REGIONAL REVIEW NOTIFICATION

Name of Proposal: Discovery Tract

Review Type: Development of Regional Impact

Preliminary Report:	October 6, 2004	DEVELOPMENT OF REGIONAL IMPACT REVIEW REPORT	Project:	Discovery Tract #605
Final Report Due:	November 5, 2004		Comments Due By:	October 20, 2004

SHEET PM-001

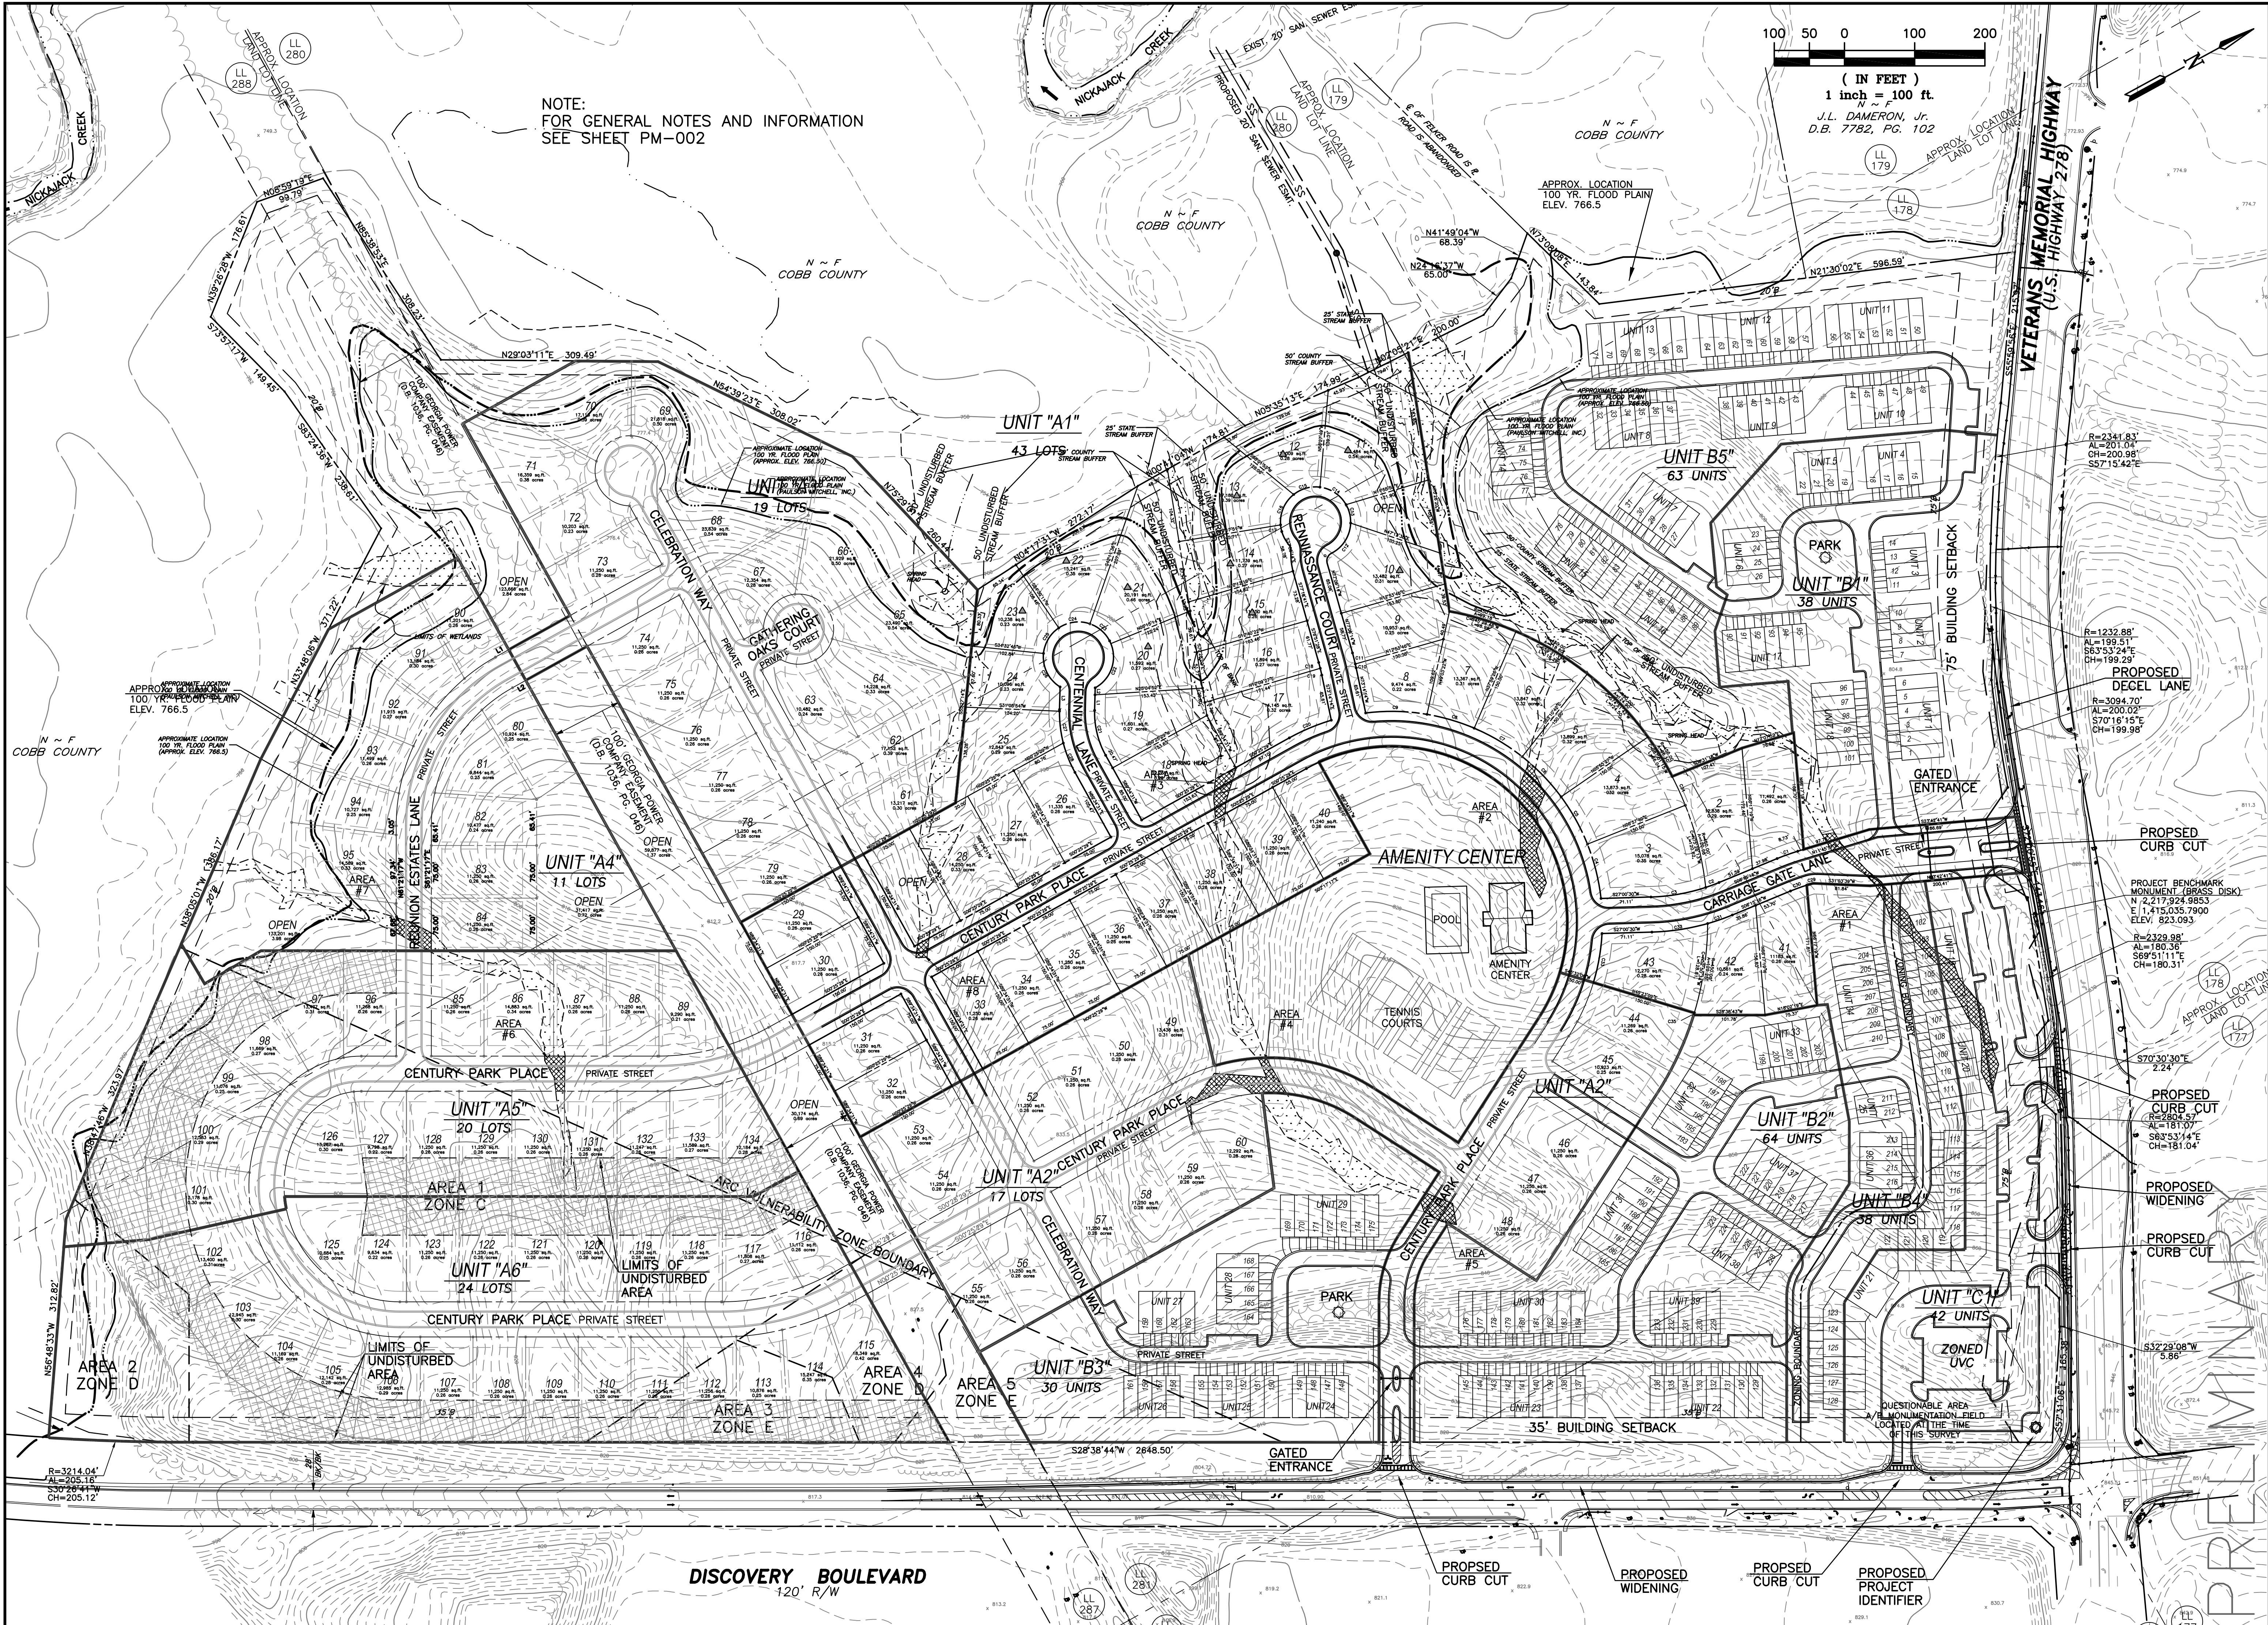
Pocket parks and open space are incorporated throughout the development as well as an amenity center. The site plan should reflect alternative pathways and convenient access for all residents to the amenity area and pocket parks, particularly the single family homes in the southwestern corner of the site.

The site plan reflects a gated community except for the retail portion located at the intersection of Veteran Memorial Highway and Discovery Boulevard. It is strongly recommended the proposed

development not be gated to ensure the connectivity of the development to other existing and future uses. Although the site plan reflects sidewalks connection throughout the site and along the exterior roadways, Regional Development Policies focus on transportation connectivity that includes future connections and linkages; therefore, gating the community would prevent allowing for future roadway and pedestrian pathway connections.
